SUBJECT: Waterford SES Unit No. 3
Docket No. 50-382
Significant Construction Deficiency No. 74
"T&B Undersized Socket Welds"

Subject: LOUISIANA POWER & LIGHT COMPANY
WATERFORD SES - UNIT NO. 3
NCR 7680 IMPACT ON SCD 74; SCHEDULE 80
UNDERSIZE SOCKET WELDS

LP&L CONSTRUCTION QA COMMENTS
 STATUS REVIEW SUS 46E
 PIPING (T&B) Walkdown Verification

TOMPKINS-BECK WITH AS-BUILT SKETCH

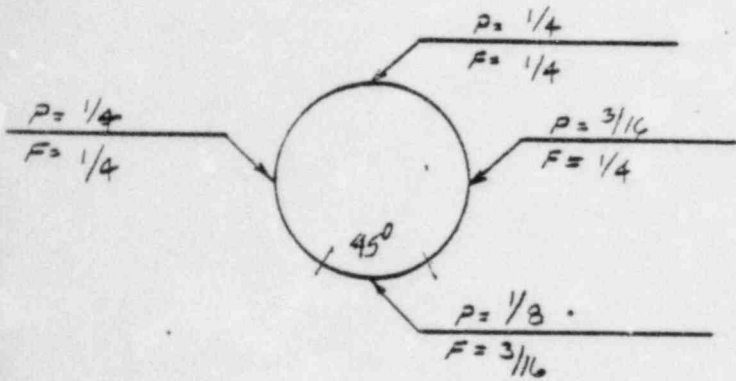
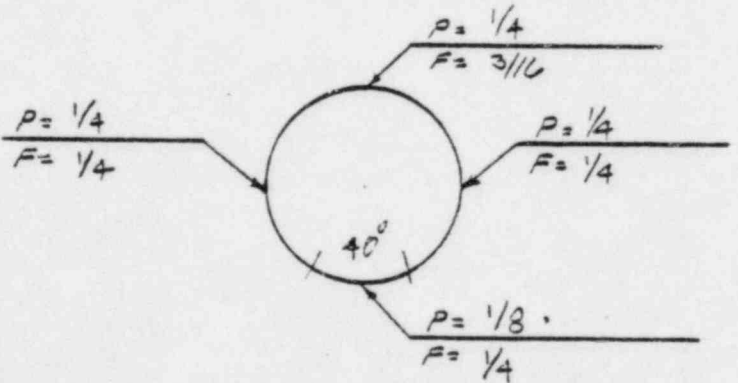
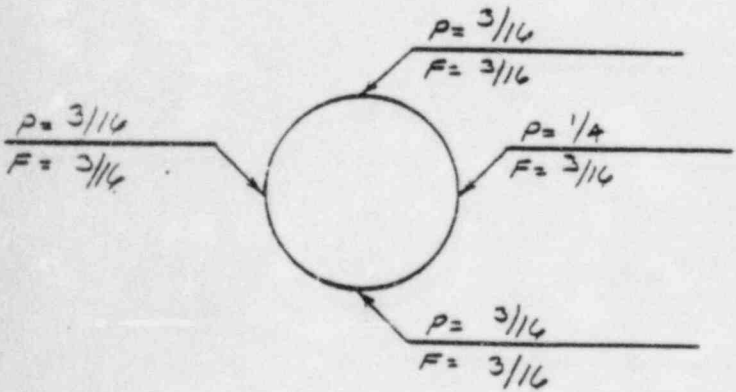
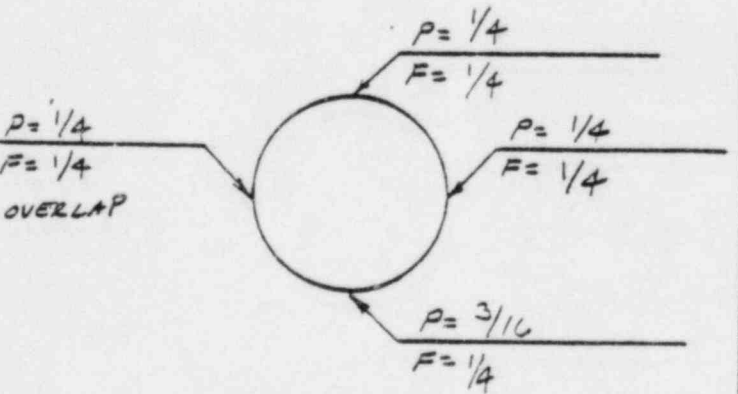
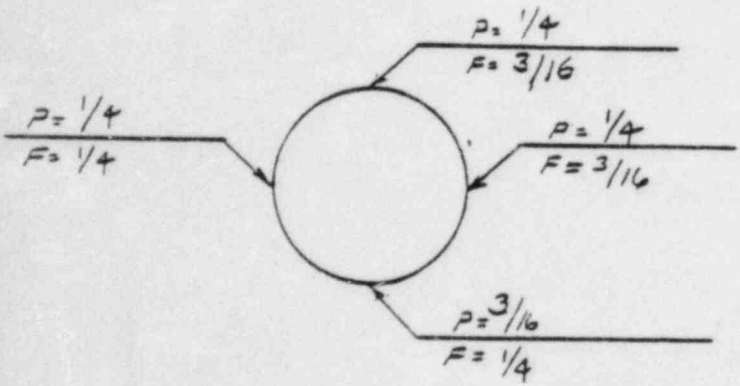
FW-2	Walkdown shows 90° ell WCR states 45° ell
FW-4	Weld undersize
FW-6	Weld undersize
FW-7	Weld was made on CC-48 not CC-47
SW-1 R-1	Weld undersize
3	Weld undersize
6 RW1	Weld undersize
SW-18 thru SW-25	These welds don't exist on pipe in field. All these documented on IW3 CC-48 by mistake.
SW-26 RW-1	Weld undersize
SW-29	Weld undersize
SW-30	Weld undersize
SW-31	Weld undersize
SW-37	Weld undersize
SW-38	Weld undersize
SW-39	Weld undersize
<u>ACIC-6</u>	
SW-59	Weld is pipe to tee, not 90° ell as shown on WCR
<u>AC-LW3-50</u>	
SW-64	Iso shows valve V720, WCR shows V727 walkdown verified valve to be V729.

ESSE TO EVALUATE WELDS

Cx = 0.144 & THROAT = 0.089 SHALL BE SATISFIED FOR SW-3, 6, 30, 31, 37 & 38 PER ANALYSIS OF WORST CASE BASIS (5/16/83 MEMO FROM A. SHAMMAN TO [unreadable])

TOMPKINS-BECKWITH AS-BUILT SKETCH

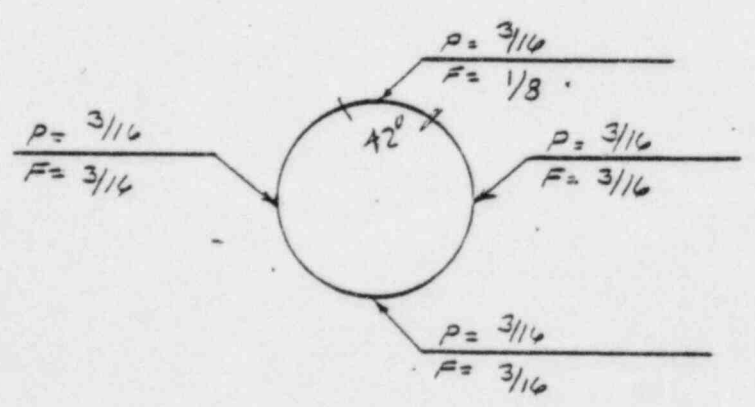
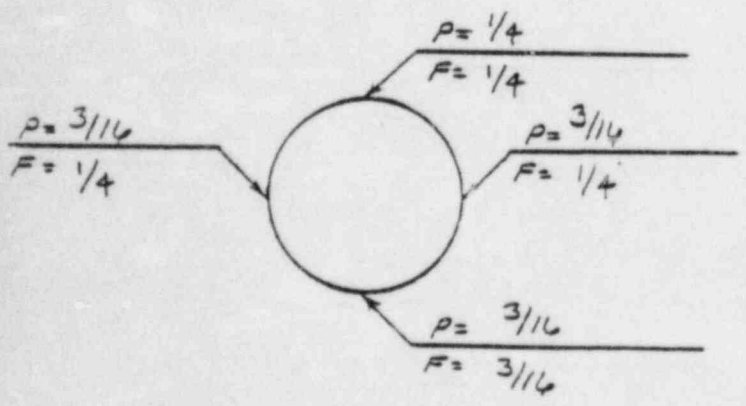
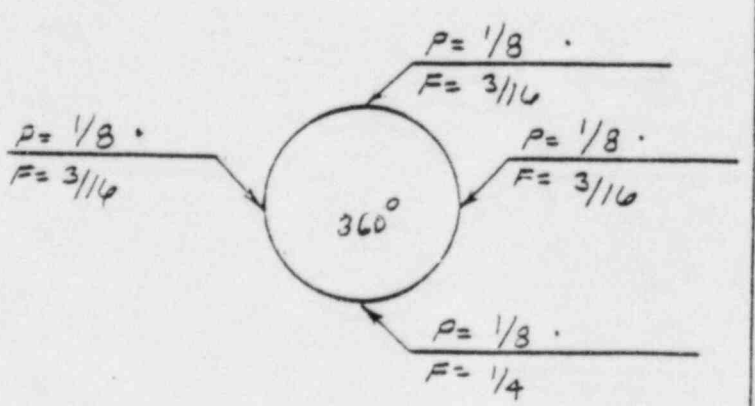
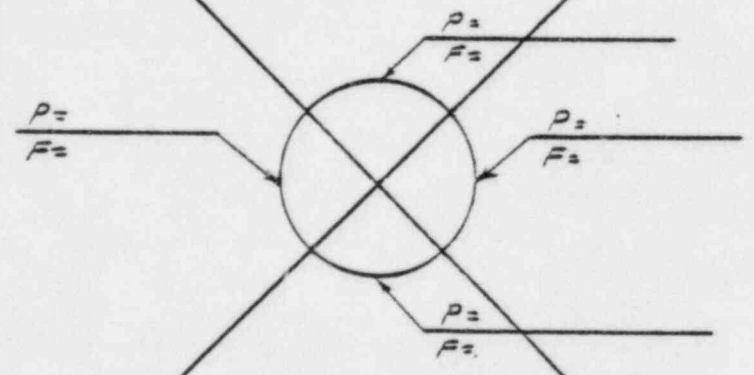
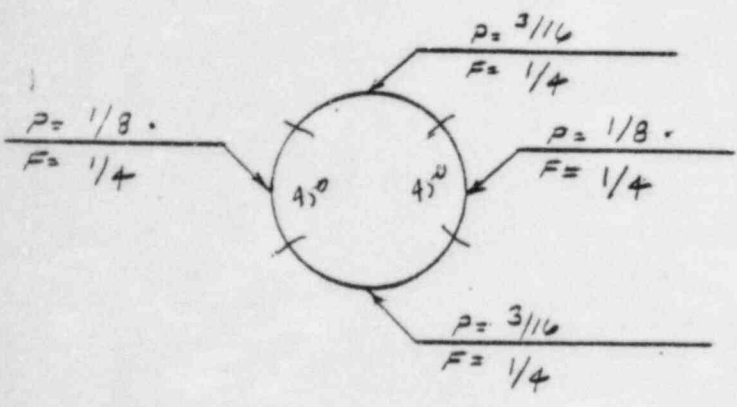
ISO. NO. LW3-CC-47
FW-2 - Comments:

Walkdown shows 90° ELL, WCR states 45° ELL.

Ebasco Q.A. Finding:

A review of Weld Control Record (WCR) shows HT#S201, review of CMTR shows HT#S201 to be 90° ELL. Based on this review and field verification we find no basis for the concern.
